Modification to Approved Project

City of Rochester, New Hampshire

Case #137-35-1-HC-21 Property Address29 Wadleigh Road, Rochester, NH						
Type of project: Site Plan; Subdivision; Line Adjustment; Other _X						
Original Project Description: 52 unit market-rate apartment building at 29 Wadleigh Road						
Date of original Planning Board approval April 4, 2022						
Description of modification: Changing 52 unit Market-Rate apartment building into 52 unit affordable apartment building; see owner-provided narrative for all building and site alterations as part of changing product type

RE: Wadleigh Road Apartments | Rapids at Cocheco – Building Plan Change Narrative

C3

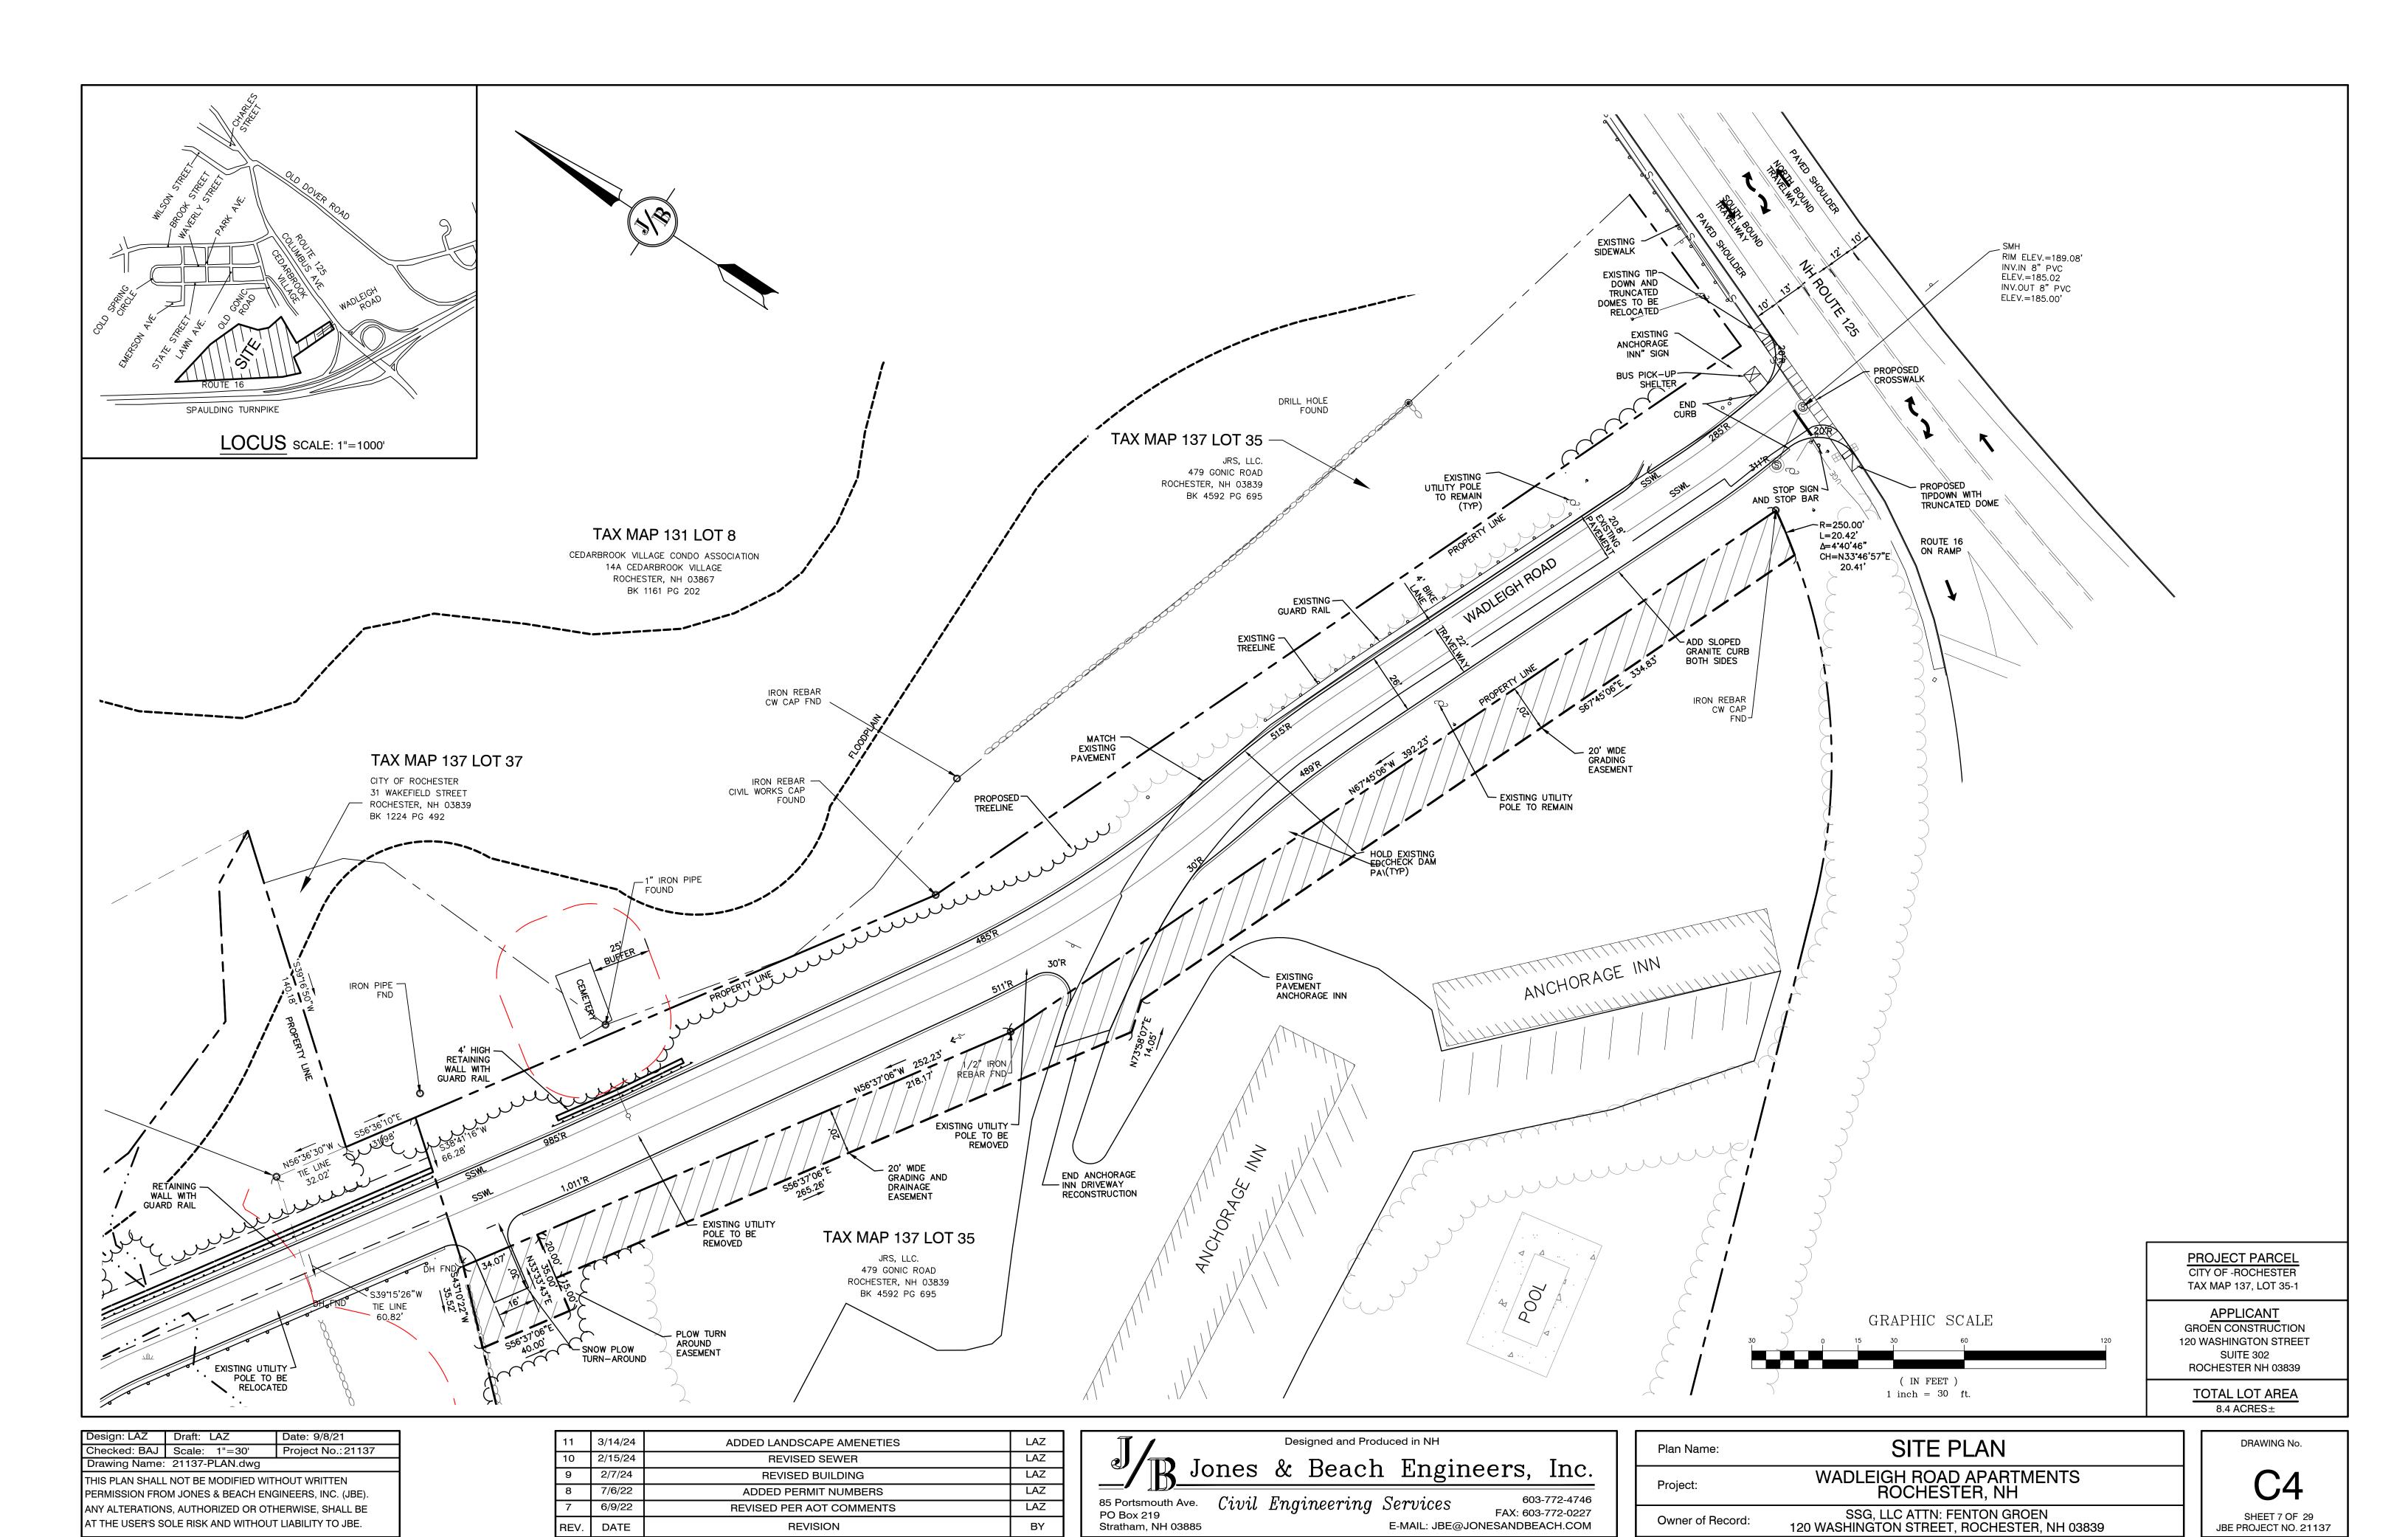
The footprint changes (indicated in the attached exhibit – see sheet C3) are primarily programmatic changes from the market rate apartments to the affordable apartments.

Reductions in the footprint range from 2.7 feet up to over 16 feet depending on the location (exhibit sheet C3); overall length of the building has been reduced by approximately 10 feet. The building height is reduced from a peak of 37'-10" to 32'-10" (see attached elevations for approved building heights compared to the new building height).
